DESIGN REVIEW BOARD

JULY 15, 2022

Design Review Board Meeting June 17, 2022

C. DRB220024 / Amazing Development Partners C-Store / 9900 Westside Parkway

SITE PLAN
SHEET **C02**

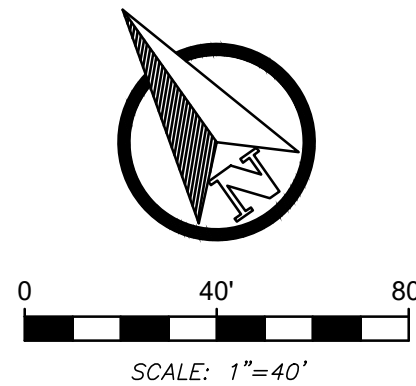
- The landscaping should maybe be a little away from the patio.
 - Do stone steps meet code?
 - What's the separation between the patio and the plaza? It's all on the same plain – separated by railing.

- Will they need a tree island? Technically, yes. According to Code, you must have a

tree in your patio.

- There will be a rail on the top of this wall.
- Is the site being irrigated?
- There should be some lower-level screening in the parking lot.
- As we redesign, there will be more turf shown on the plan.
- You're planning on coming back with more refined plans, correct? Yes.
- Is there an opportunity to put seating?
- Are the knockout roses high maintenance? Yes- they can be hit or miss.
- Whoever manages needs to know how to correctly manage the landscaping.
- Do you feel the upper storefronts have enough signage? The trees you're planting can grow up to 30 feet.
- The glass on the tower – shouldn't it be regular glass?
- This can be changed out to be more consistent with brick.
- Is everyone okay with the overall structure? We are okay with the massing.
- The dark spots with the black brick – are they in plain? Yes.
- The corner materials are stone.

- There were no public comments for this item.
 - The applicant consented to all motions on this item.
 - ❖ Vice-Chair Schwing offered a motion to approve the site plan as presented, with the understanding that the details of the plaza patio and access to the public sidewalk will come back for approval.
